Well Name: POKER LAKE CVX JV BS

Sundry ID: 2909586

PLUG AND ABANDON WELLBORE
POKER LAKE CVX JV BS 009H
EDDY COUNTY, NEW MEXICO
Class II

Sundry ID: 2917577

POKER LAKE CVX JV BS 009H- Proposed WBD

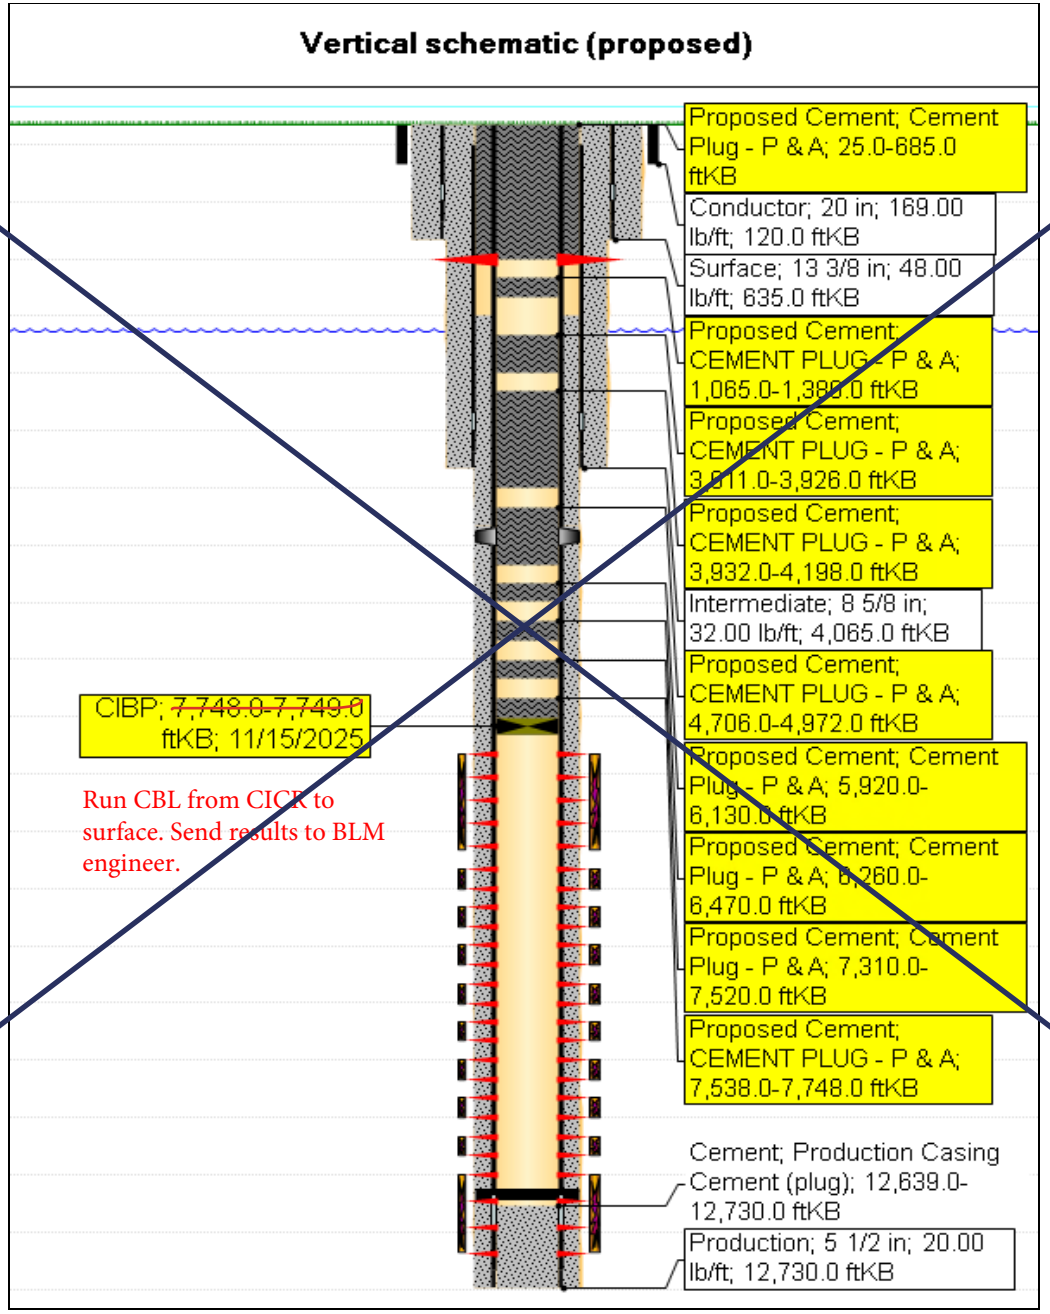
DO NOT USE THIS PROPOSED WBD IT WAS REPLACED WITH THE ATTACHED HORIZONTAL WBD

REVISED
1:22 pm, May 11, 2026

Spot 25 SKS **Class H** cement from 6,130′ to 5,920′

Spot 25 SKS **Class H** cement from 6,470′ to 6,260′.

POKER LAKE CVX JV BS 009H- Proposed WBD

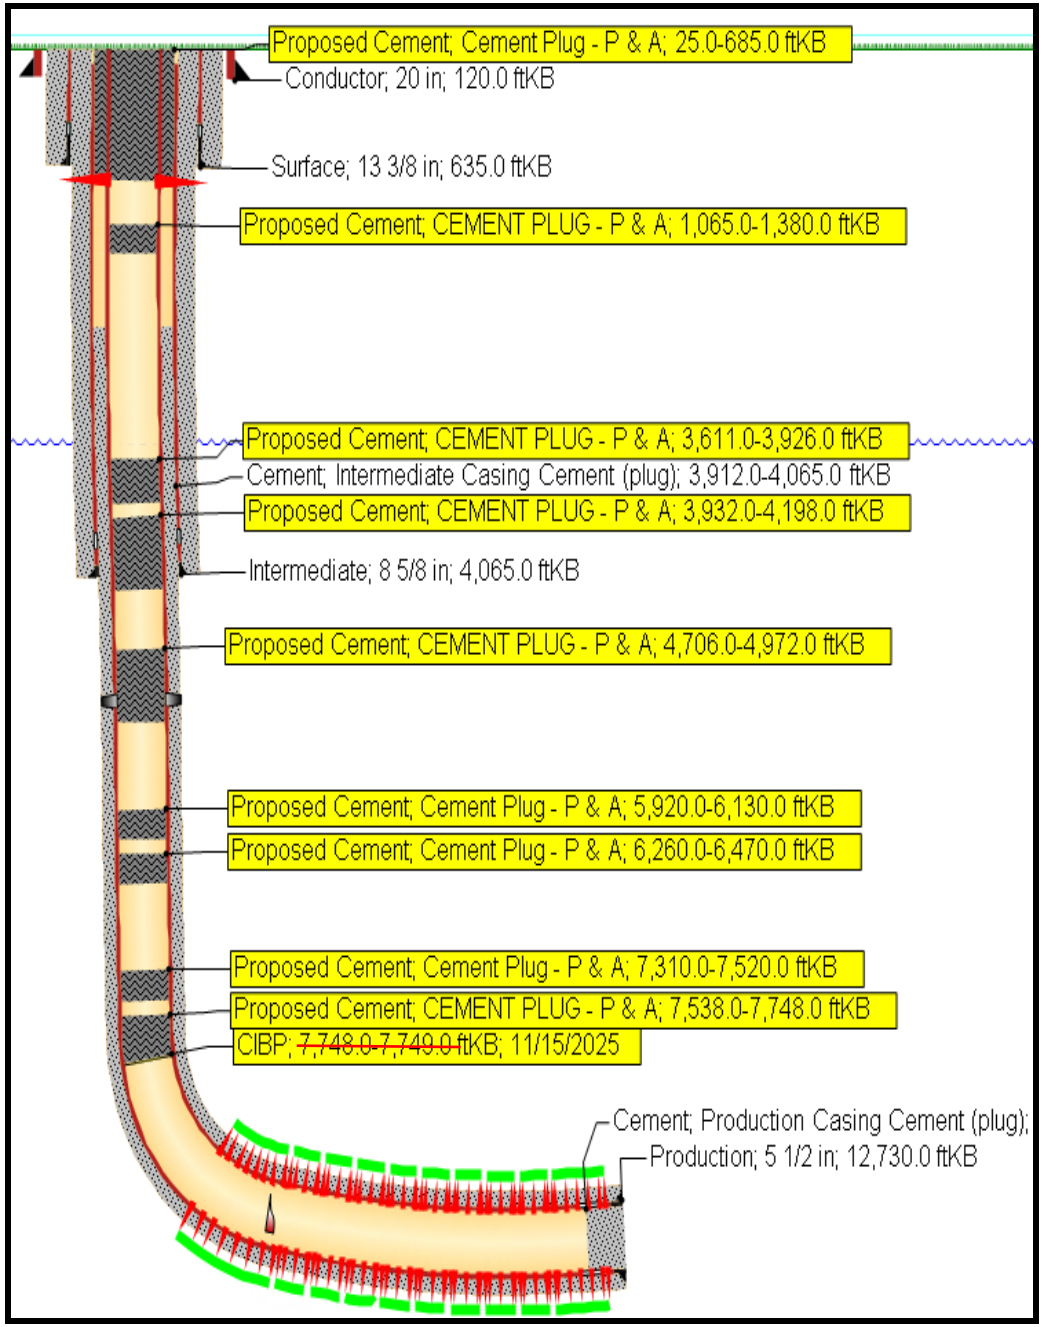
Procedure Description: XTO Permian Operating LLC, respectfully submits the attached Proposed Horizontal WBD to replace the Proposed WBD previously included with the NOI to P&A, in accordance with NMOCD's request. The original NOI was approved by BLM on 5/11/26. The Proposed Horizontal WBD has been updated to include the revisions made by BLM.

Spot 25 SKS **Class H** cement from 6,130′ to 5,920′

Spot 25 SKS **Class H** cement from 6,470′ to 6,260′.

Determine injection rate into open perforations. Set CICR at 7000′. Displace 150 sxs Class C, 9 ppg from 7000′ to 7996′. Sting out of CICR and spot 25 sxs on top. Pressure test CICR. Run CBL from CICR to surface.
